# Attachment I

Staff's Fate & Transport Modeling

Figure 2: Model simulation results to calibrate to observed uranium levels downgradient of the production zone during baseline conditions. The level downgradient of the production zone is 0.02 mg/L.

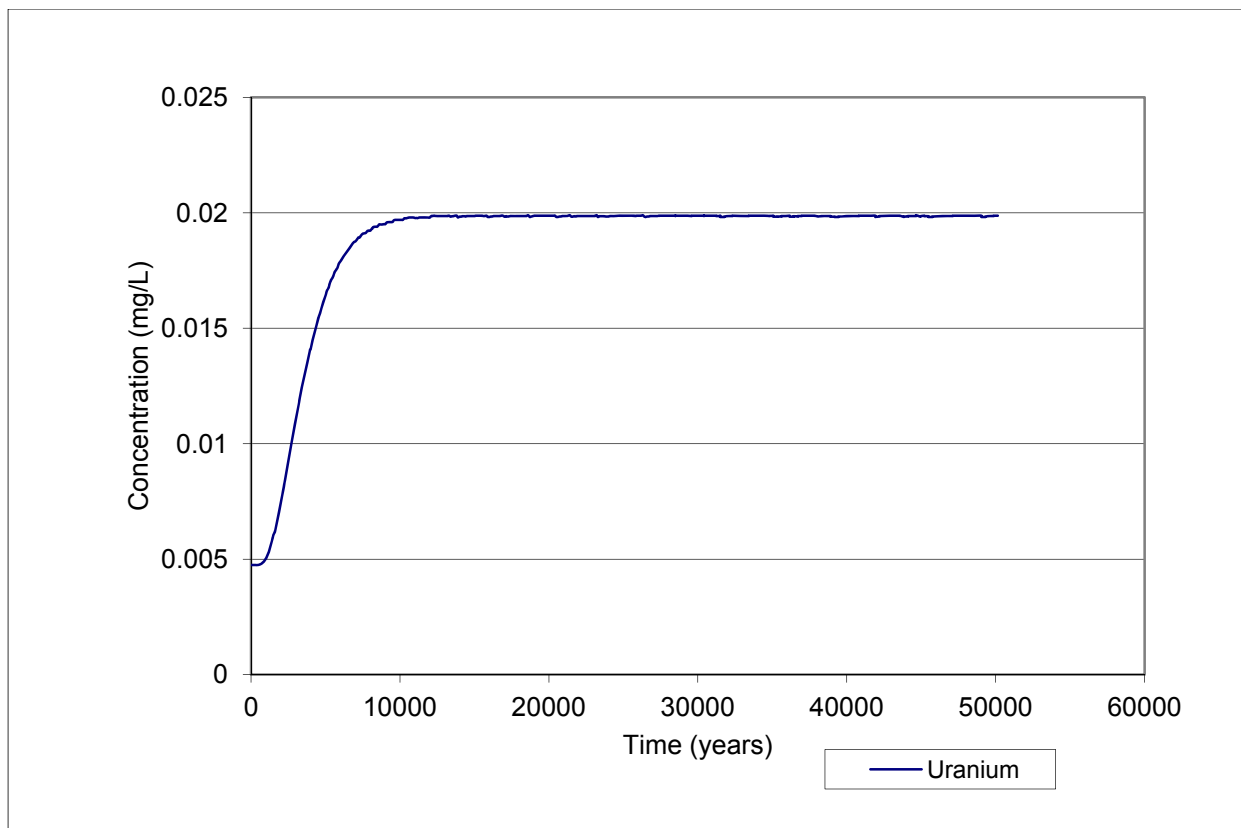
Based on the above assumptions, the values for dispersivity and distribution coefficient were adjusted to yield the long-term downgradient levels (Figure 2). The adjusted values for longitudinal dispersivity, ratio of vertical to longitudinal dispersivity, ratio of transverse to longitudinal dispersivity and distribution coefficient are as follow:

Longitudinal dispersivity	11 feet
Ratio of vertical to longitudinal dispersivity	0.6
Ratio of transverse to longitudinal dispersivity	0.1
Distribution coefficient	10 cm <sup>3</sup> /g

Figure 3: Model simulation results to calibrate to observed radium-226 levels downgradient of the production zone during baseline conditions. The level downgradient of the production zone is 0.047 pCi/L. The model incorporated dispersivity of the uranium simulation.

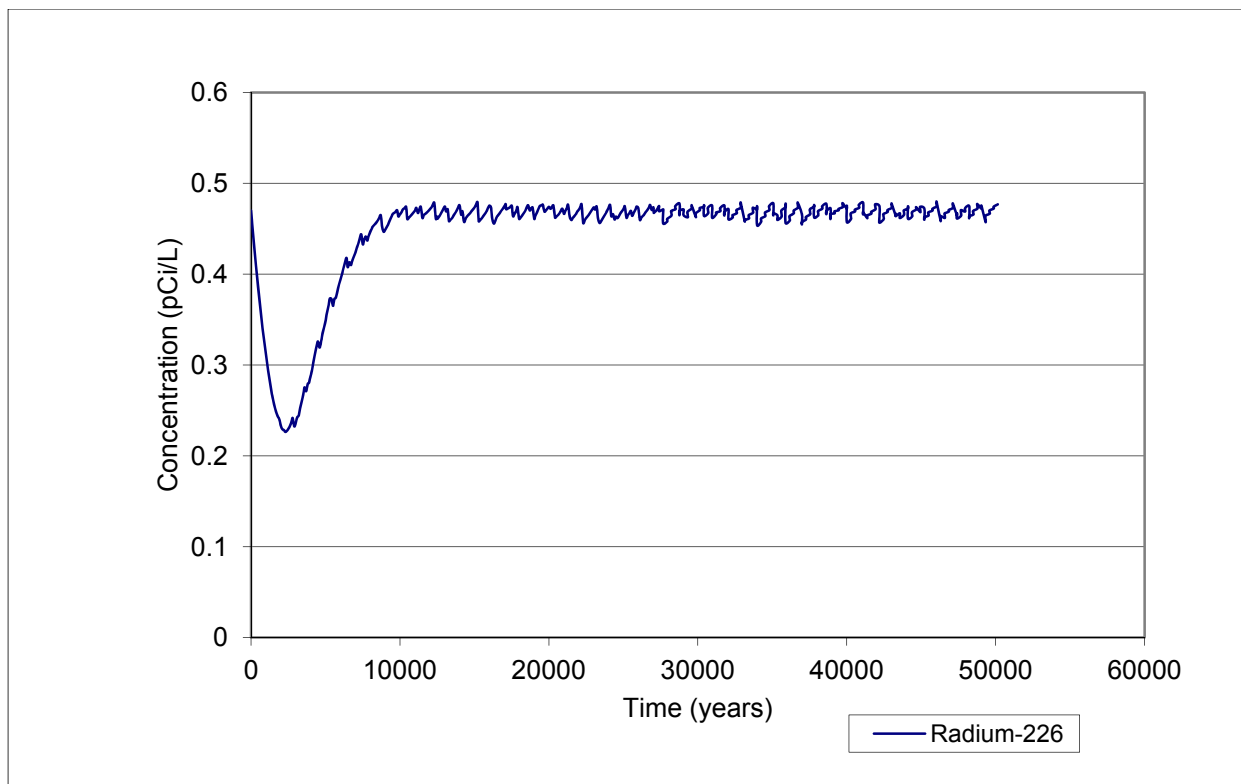
The radium data could not be used to estimate dispersivity values. However, the dispersivity values determined for uranium were applied to the simulations for radium-226. Consequently, the unknown parameter for the radium-226 simulation was the distribution coefficient. Using the dispersivity values determined for uranium, the value of the distribution coefficient that yielded the long-term radium-226 levels was 30 cm<sup>3</sup>/g (Figure 3). This value is consistent with published distribution coefficients for radium in similar settings as ISR's (Kirby & Salutsky, 1964; Szabo, et al., 2012).

Figure 1. Map View of Model Geometry

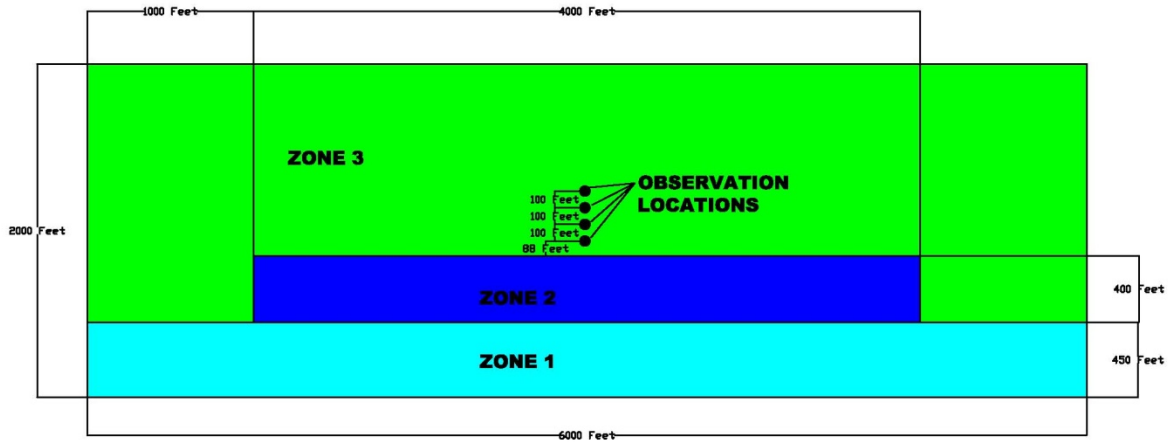
Three zones were set up in the MT3DMS model. The zones are shown on Figure 1. Zone 1 represents the area downgradient of the production area, Zone 2 represents the production area and Zone 3 represents the area upgradient of the production area.
